SERVICE TECHNICAL INFORMATION

ONE POINT REPAIR

MODEL : TV-1402KE/2002KE/2102KE

SUBJECT : Part Number of EEP ROM (IC002/NVM3060)

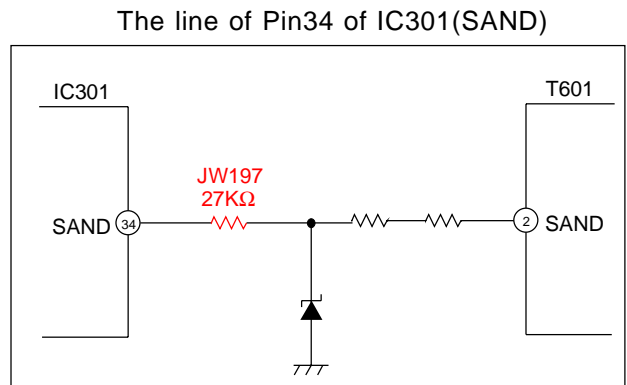
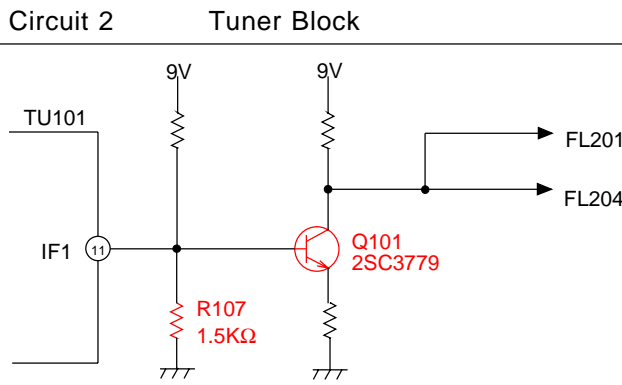
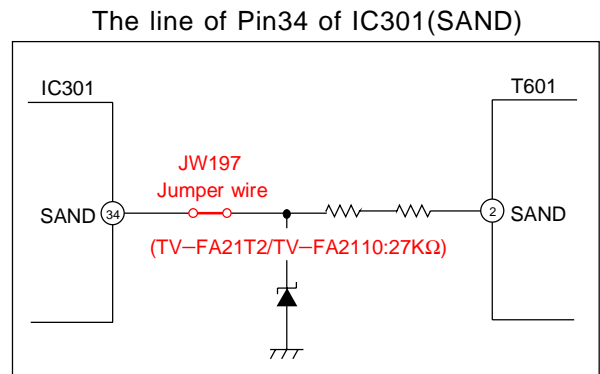
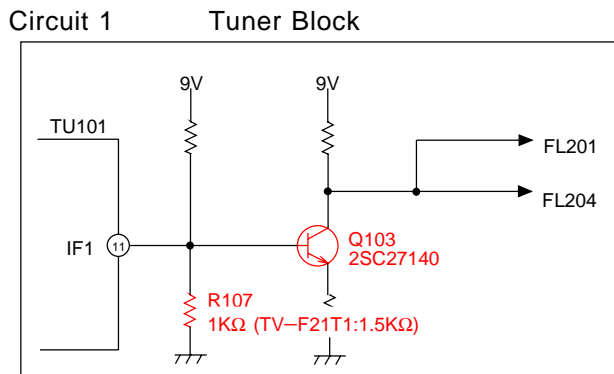
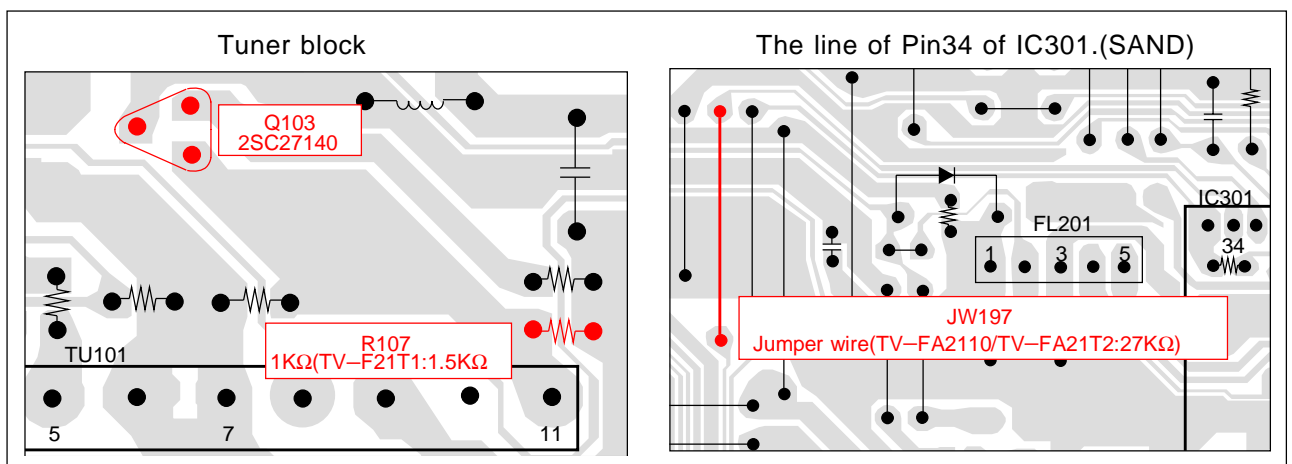
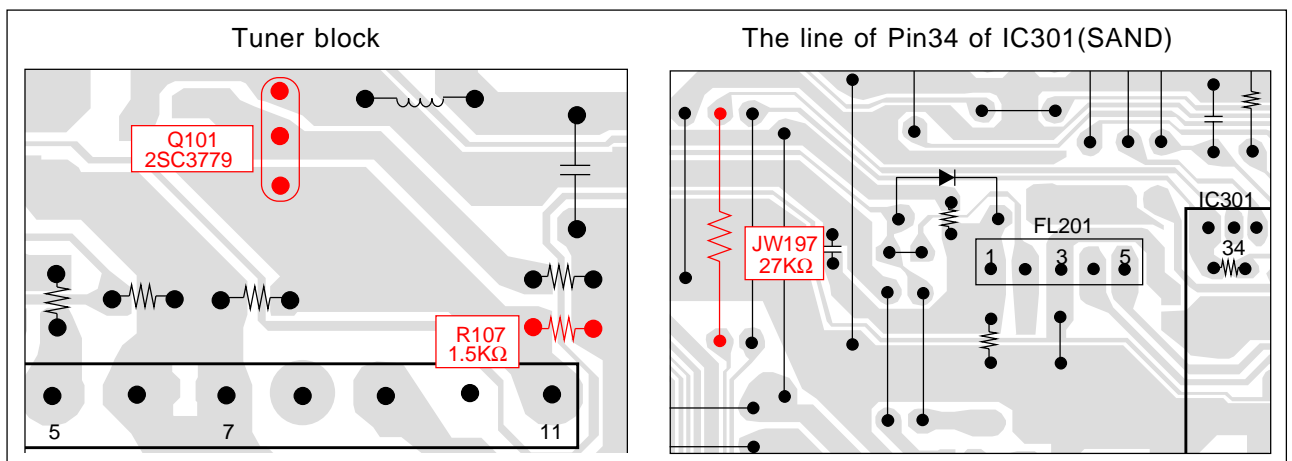
The peripheral circuit that is connected to Pin 34 of IC301 in TUNER block has been changed. Please confirm the circuit construction(Circuit or Circuit 2), and use the appropriate parts for each type of the circuit.

Modifications			
Ref No.	Circuit 1	Circuit 2	Affected Models
Q101	No mounting	TR,2SC3779	All models(On tuner block)
Q103	C-TR,2SC27140	No mounting	All models(On tuner block)
R107	C-RES,U 1K-1/16W	C-RES,U 1.5K-1/16W	TV-FA21T2 / FA2110 only (On tuner block)
JW197	Jumper wire	RES,27K-1/8W	TV-F21T1 only (On the line of IC301 Pin34)

The improper use of spare parts will be cause of the beat noise on Aerial.
 When the buzz noise arises on Aerial or line input of TV-F21T1(Circuit 1), mount the 27KΩ instead of JW197.

Ref.	Parts Code	Description	Remarks
JW197	88-121-273-080	RES,27K-1/8W J	-

fig.1

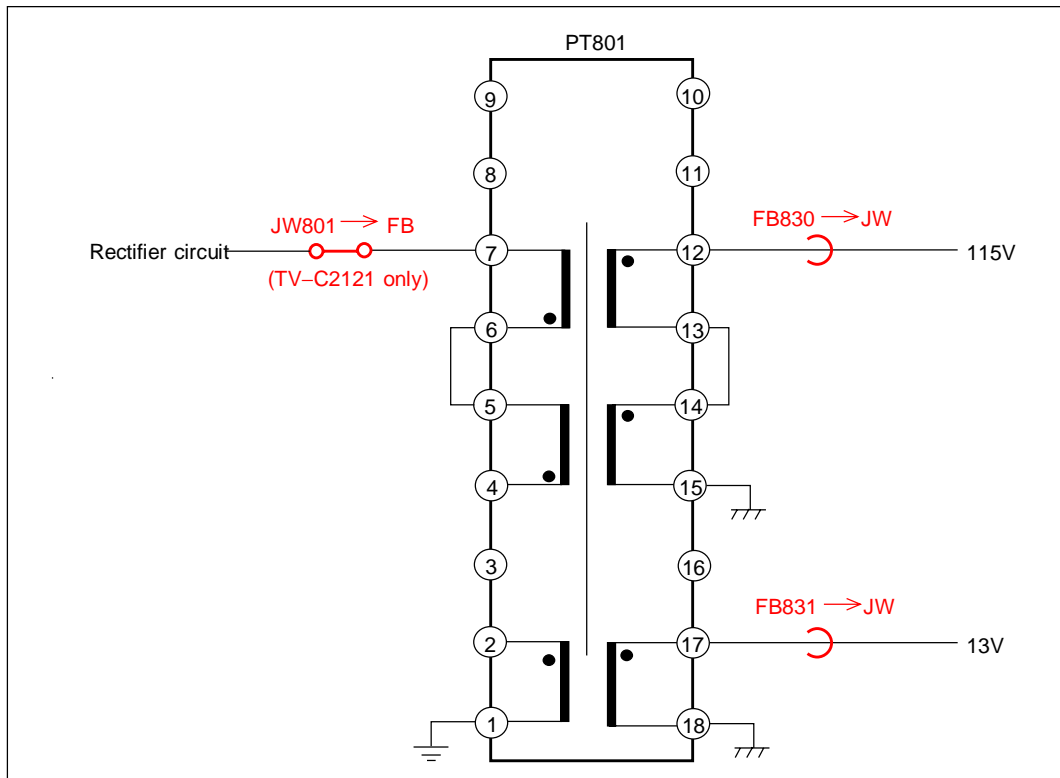
To avoid being influenced, modify the power circuit as following countermeasure.

1. Replace the FB830 and FB831 in the secondary stage of the power supply to the jumper wires. (see fig.2)
2. Remove the JW606 and JW608 which connect the GND traces.(see fig.3)
3. Replace the JW801 at the primary stage of the power circuit to the ferrite beading.(see fig.4)

fig.2

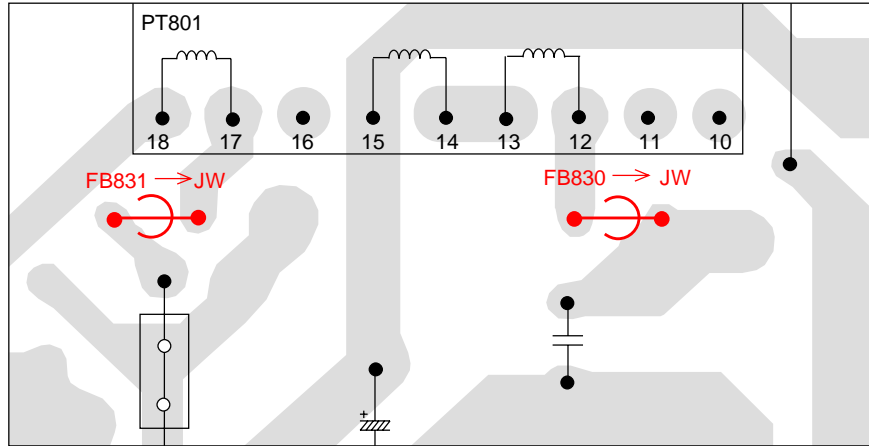
1. Replace the FB830 and FB831 of the secondary stage of the power supply to the jumper wire.

fig.3

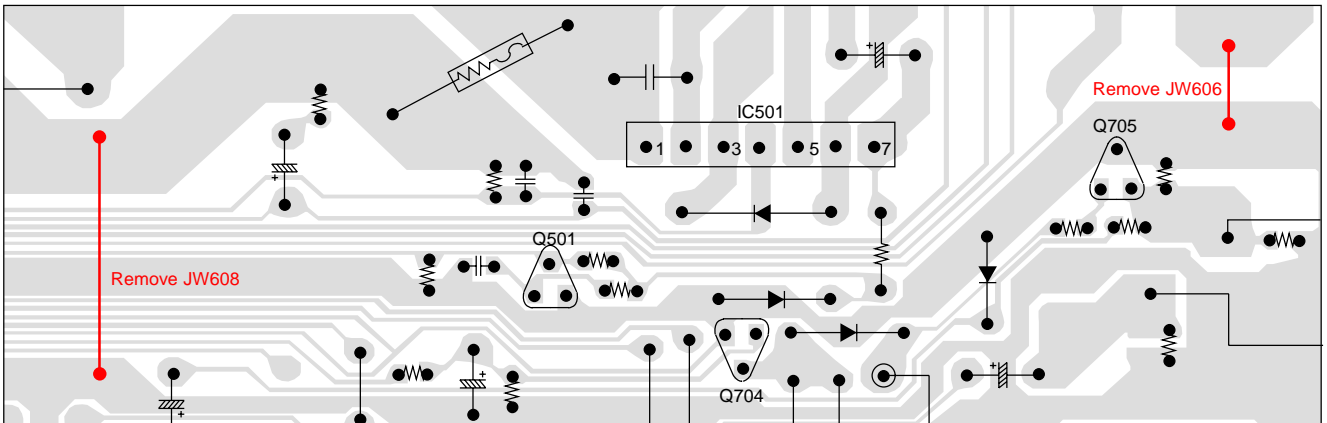
2. Remove the JW606 and JW608 which connect the GND traces.

fig.4

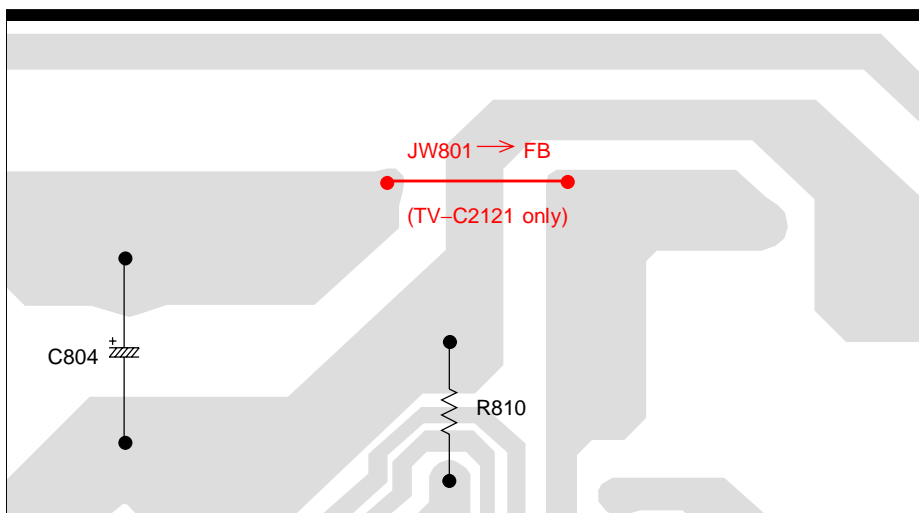
3. Replace the JW801 at the primary stage of the power circuit to the ferrite beading.

Ref.	Parts Code	Description	Remarks
JW801	87-003-320-080	F-BEAD,FBR07HA121NB	-

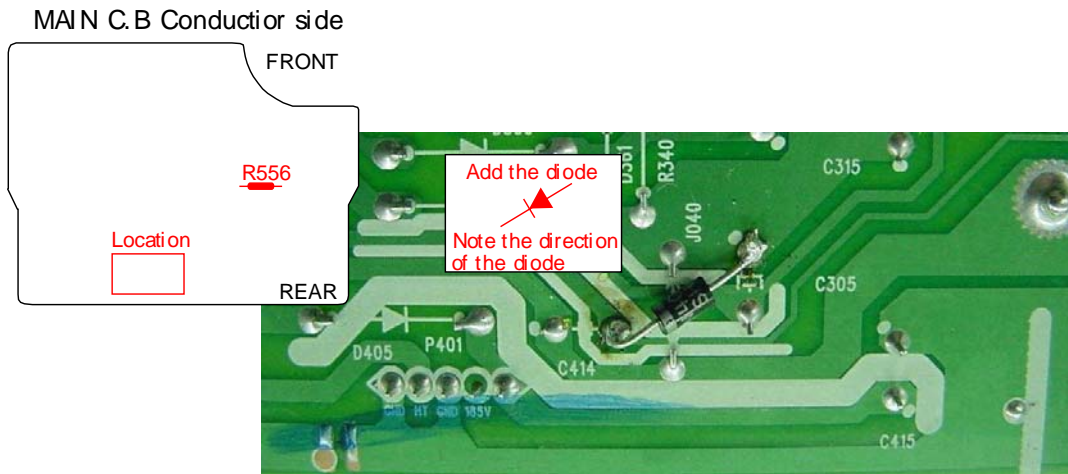
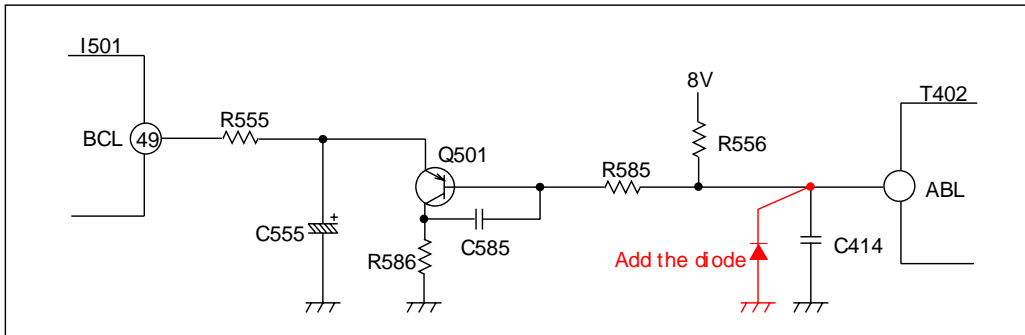
- 1) Replaced a CRT.
- 2) A failure of R556 was confirmed.

1. Add the diode between C414 and C305(GND) as the picture below.
2. Fix it with a glue.
3. Confirm a value of resistor, a color of R556, and replace it if found any defect.

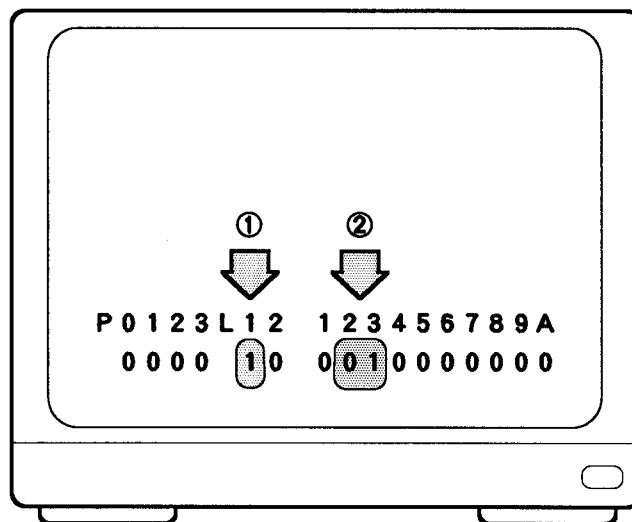
SUBJECT : Service manual of the model in question contains an error in service-mode setting values to be specified after replacing EEP ROM. Setting of erroneous value may lead to a failure in Portuguese OSD display.

- Correct the service manual setting of OSD display into values shown in the following figure.
- After a repair, set to the specified values .

The correct values for ① and ② of TV-A215RH must be set as shown in the figure. After repairing the EEP ROM ,set the values as shown in the figure.

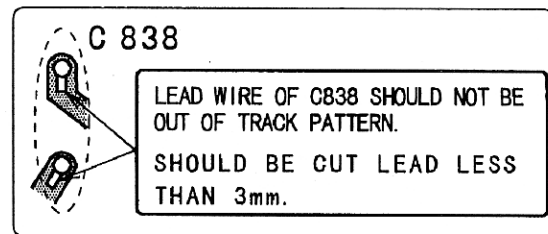
MODEL : TV-C2120 DH
 SUBJECT : No power is turned on.
 DESCRIPTION : The power may not be turned on due to a faulty ceramics capacitor (C838) on the power circuit. Regardless of the indicated phenomenon of faulty details, exchange the undesirable capacitor (C838) with a one of the specified type. At the same time, if any peripheral part is damaged and the equipment cannot be operated, exchange the part with a new one.

- Specified capacitor: C838
 1000P • 1K K → 1000P • 1K K R
- When the equipment does not operate due to a faulty peripheral part, exchange the following parts with new ones.
 IC801, F801
- During soldering, take great care to the following respects.

Ref.	Part Name	Part No.	Remarks
C838	CAP, CER 1000P-1K K R	87-A10-832-01/08	CHANGED FROM 87-016-515-080
IC801	IC, STR-S6707	87-A20-517-010	
F801	FUSE, 4A 250V T 218	87-035-458-010

Fig-1

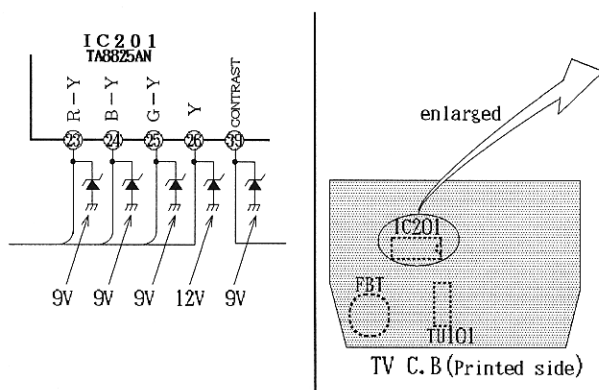
1. Connect 9.0 V ZENER DIODE (KIT, A TV-1452) between IC201's PIN23 and GND, PIN24 and GND, PIN25 and GND, PIN39 and GND (See Figures 1 & 2).
2. Connect 12 V ZENER DIODE (KIT, A TV-1452) between IC201's PIN26 and GND (See Figures 1 & 2).

Figure 3: TV C. B (Parts side)

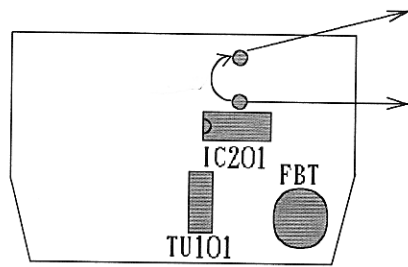
3. Move C206 to the position designated in Figure 3.

Removed capacitor must be mounted here.
"C206" is displayed. Make sure the polarity is correct.

Figure 4: CRT C. B (Printed side)

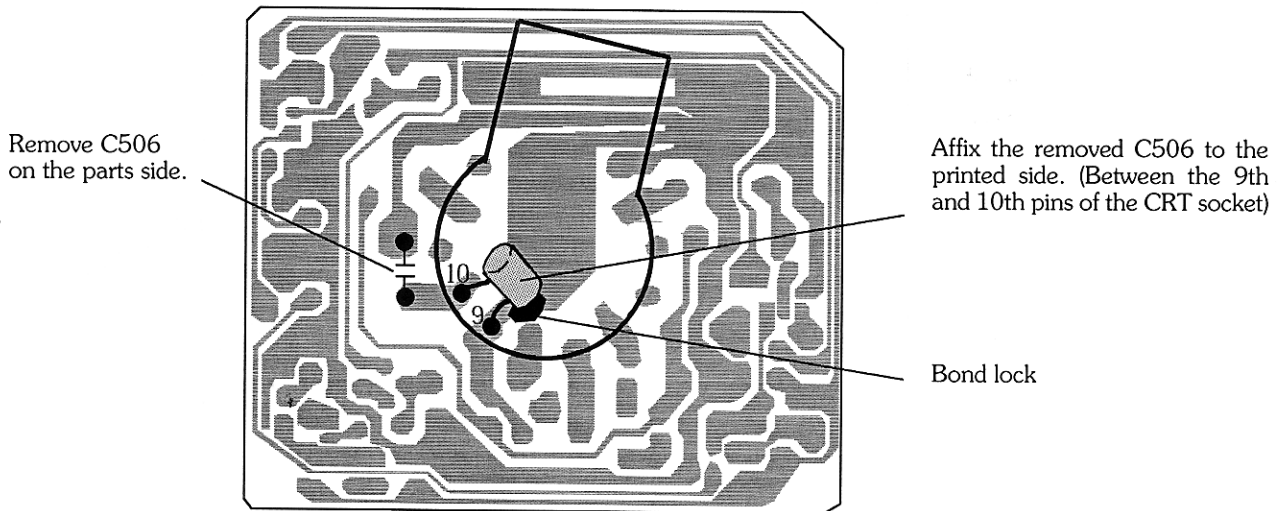
4. Remove C506 mounted on the parts side, and affix it to the printed side as shown in Figure 4.
